Comments Requested on a Notice of Proposed Rule Making for the Modification of Class D Airspace & Establishment of Class E Airspace at San Bernardino International Airport (SBD)

Background- Summary of Airspace Change Proposal - FAA's July 2, 2024 , Memorandum, Subject: Revised Airspace Review – SBD

Redlands Airport Association Assessment of the Airspace Change

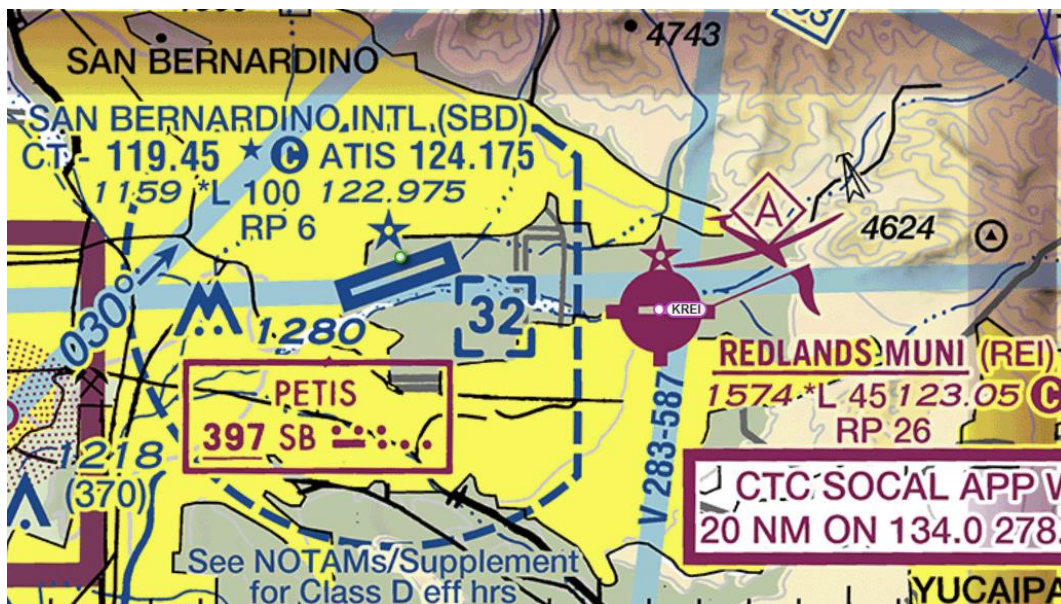
- The current western boundary of the Class D airspace does not fully contain the IFR departure operations of the RWY 24 ODP while between the surface and the base of adjacent controlled airspace, nor would it fully contain RNAV (Required Navigation Performance [RNP]) X RWY 6 IFR arrival operations while between the surface and 1,000 feet above the surface. A 4.2-mile-

wide extension centered on the airport's 250° bearing extending a half mile west of its 4.5-mile radius should be added to the existing boundary to sufficiently contain these operations.
